Re: Fw: RV7 HS Construction Questions

> Subject: RV7 HS Construction Questions

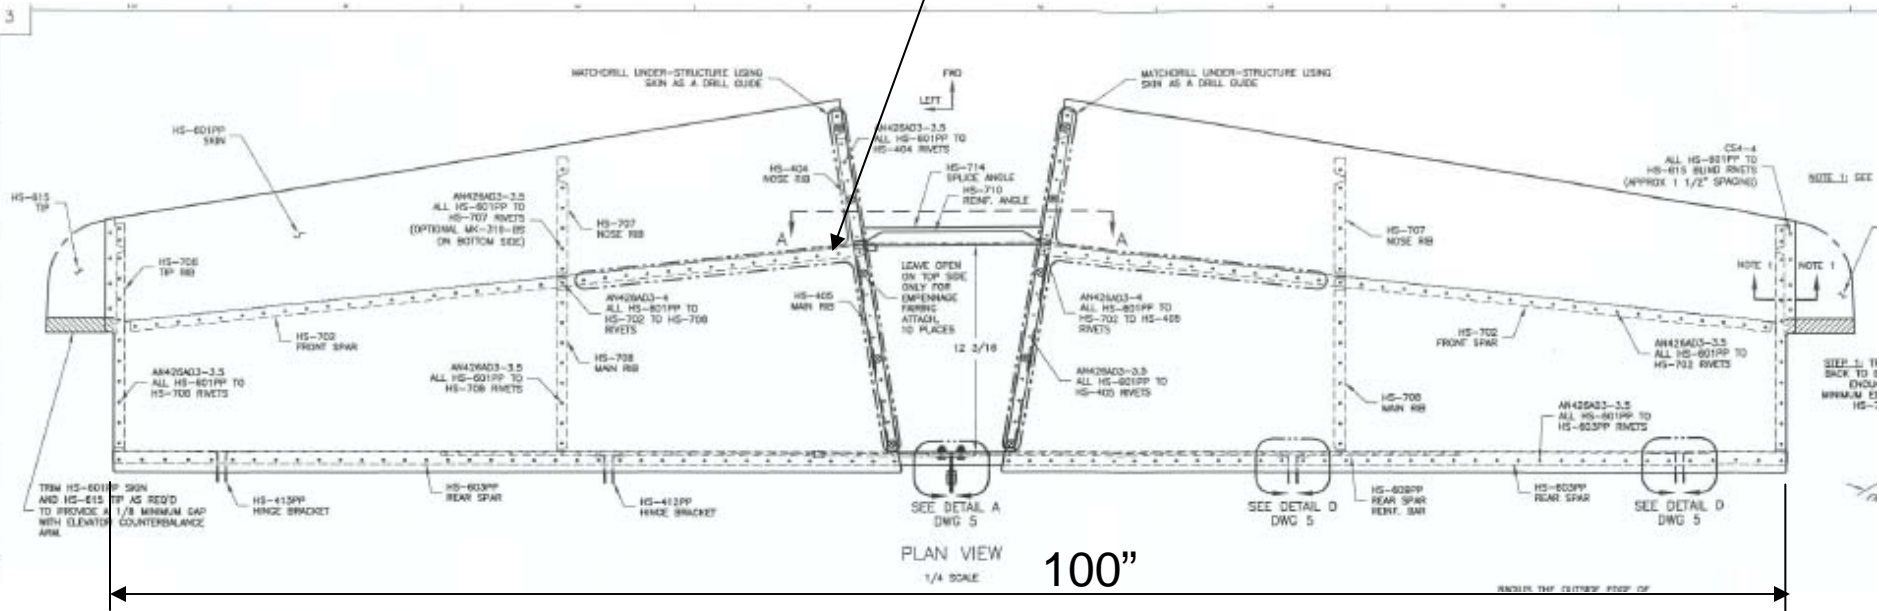
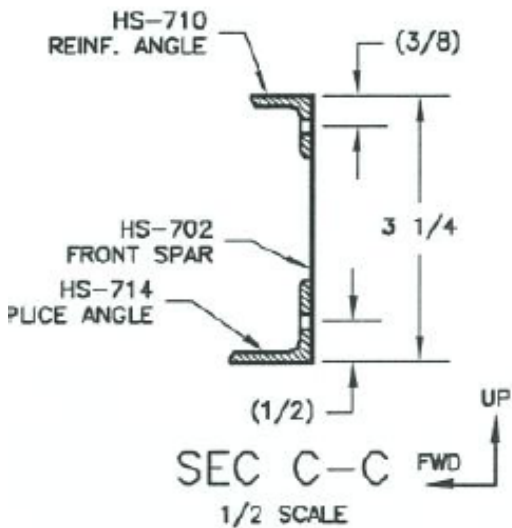
Cause: rivet gun slipped during riveting

Approximate location of the dent

> Started riveting the HS, and made some mistakes. I have attached a
> PPT file for illustration.
> 1) Are the smiley on the HS702 ok structural wise?

Thanks, Gus! The area dented by the rivet gun doesn't feel rough (no feeling of any burr or scratch) when running my finger over it, I guess I will just keep the way it is, and will check it during annual (the first annual will be at least 4 years away :-))

I don't think they'll be a problem. You could use some scotchbrite or emery cloth to smooth any rough edges just to minimize the chance of cracks in the future.

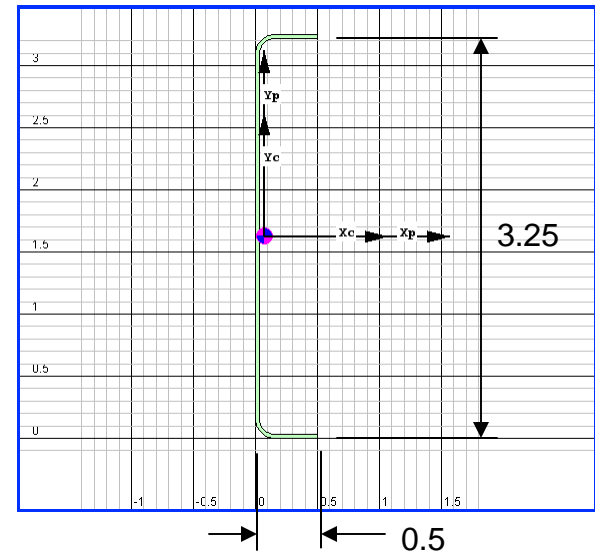
Conservatively only consider the front spar channel at the dent location

Assuming a total of 600 lbs is uniformly applied at horizontal stabilizer. The moment will be taken by both the front and rear spars. The stiffness of rear spar is higher, so the rear spar will take more moment than the front. Assuming the front spar will take half of the total 600 lbs, the dented location will see a shear force of 150 lbs.

$$V=150 \text{ lbs}$$

$$A = 0.032 \times 3.25 = 0.104 \text{ in}^2 \text{ (ignore the flange area)}$$

$$\text{Shear stress} = 150/0.104 = 1.44 \text{ ksi}$$

Stress is very low, and the buckling shear strength is 15 ksi (see next slide), not a concern. The smoothness over the dent area is checked ok, and no initial cracks observed, fatigue is also not a concern here.

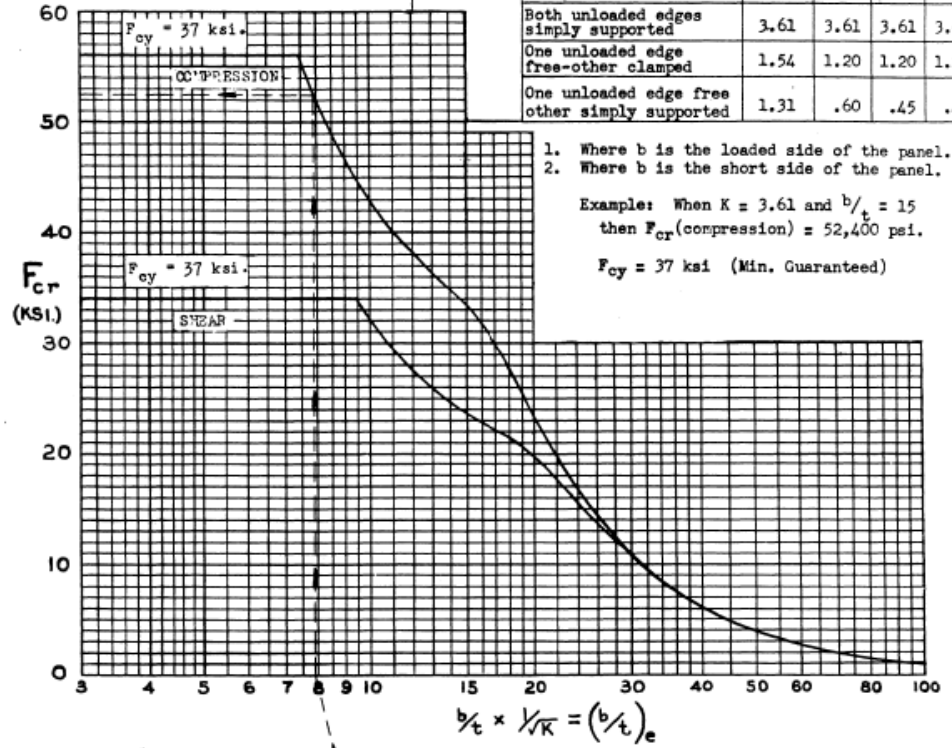
Buckling Strength:
 For $b/t=3.25/0.032 = 101$
 $K = 21.6$
 $F_{cr} = 15 \text{ ksi}$
